Rezoning Application: PD 26-0426

**Hillsborough
County Florida**

This is a request to rezone a site from Planned Development (PD) and AS-1 (Agricultural, Single-Family) to a Planned Development to allow a 346-unit multi-family development. This application includes a flex request of the RES-20 Future Land Use category found to the west.

AGENCY REVIEW COMMENT SHEET

8.0 PROPOSED SITE PLAN (FULL)

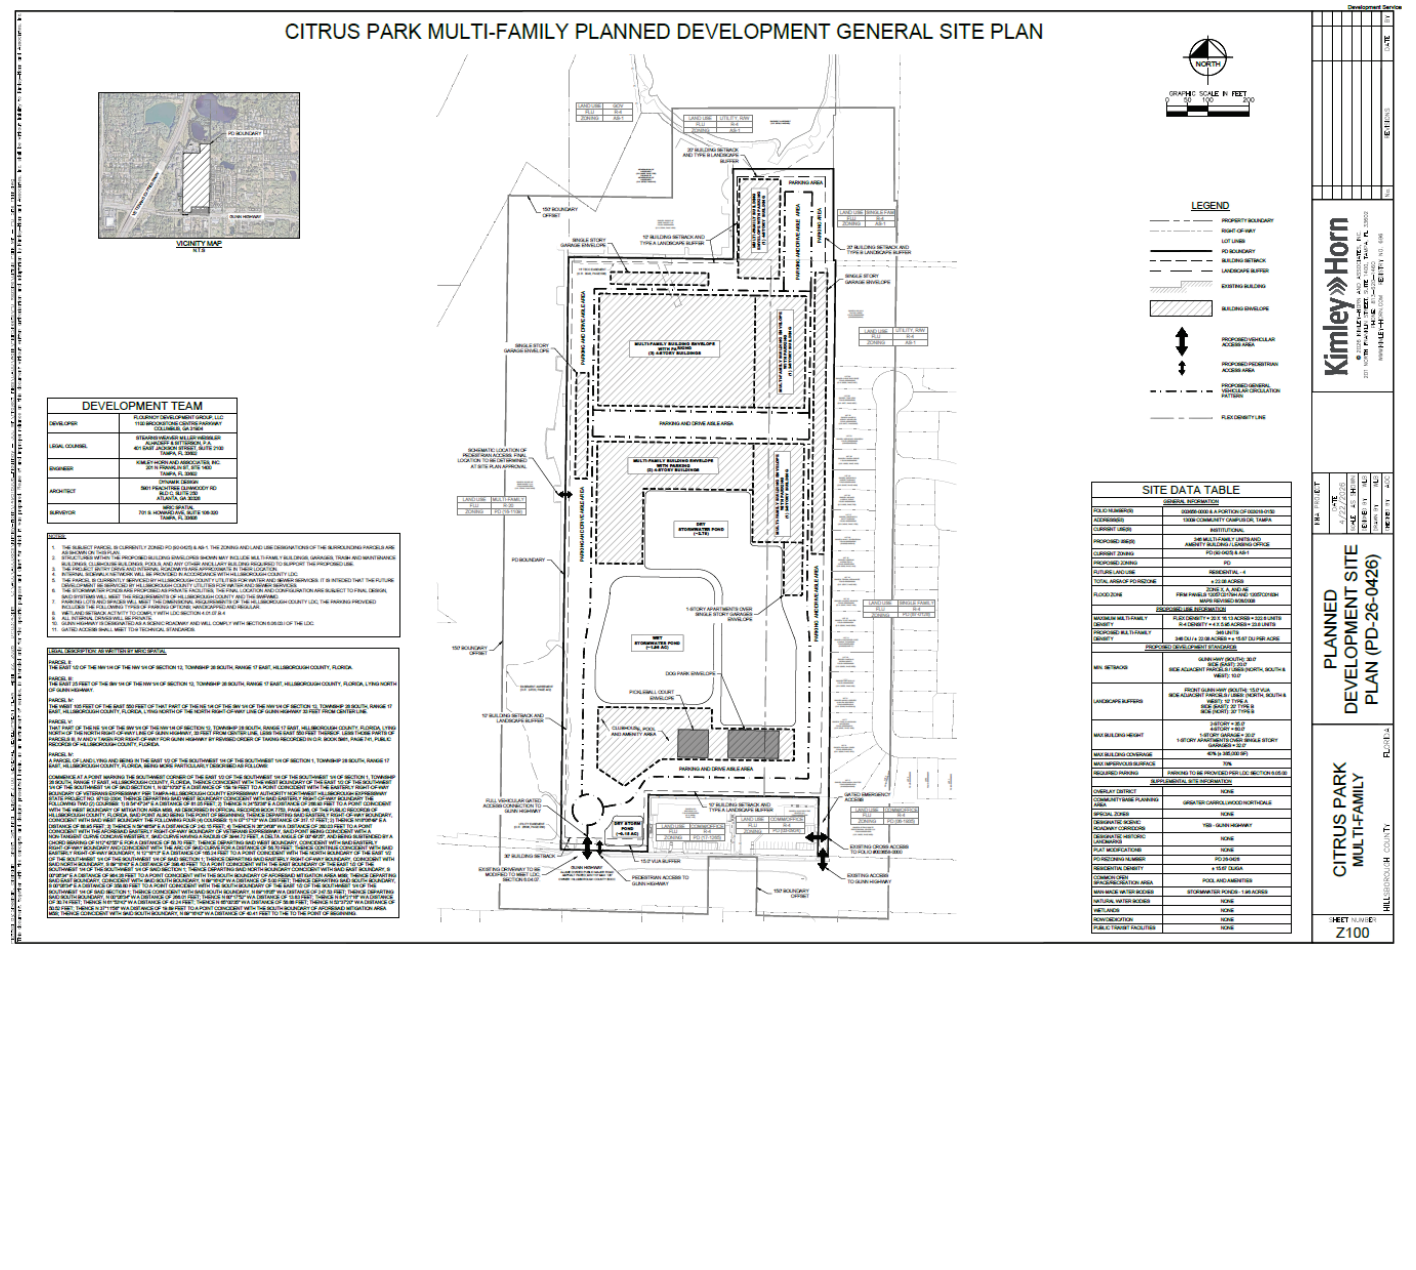
1. Prior to PD General Site Plan certification, the applicant shall revise the PD site plan label stating “Existing driveway to be modified to meet LDC, Section 6.04.07.” to “Existing driveway to be modified to meet the LDC, Sec. 6.04.04.A.3. residential development maximum driveway length.”
2. Prior to General Site Plan certification, the applicant shall revise the PD site plan proposed general vehicular general circulation pattern to connect to the proposed gated emergency access.
3. General Site Plan to provide a maximum building height for the amenity center at 35 feet.

- Prior to PD site plan certification, the applicant shall revise the PD site plan label stating "Existing driveway to be modified to meet LDC, Section 6.04.07." to "Existing driveway to be modified to meet the LDC, Sec. 6.04.04.A.3. residential development maximum driveway length."
- Prior to PD site plan certification, the applicant shall revise the PD site plan proposed general vehicular general circulation pattern to connect to the proposed gated emergency access.
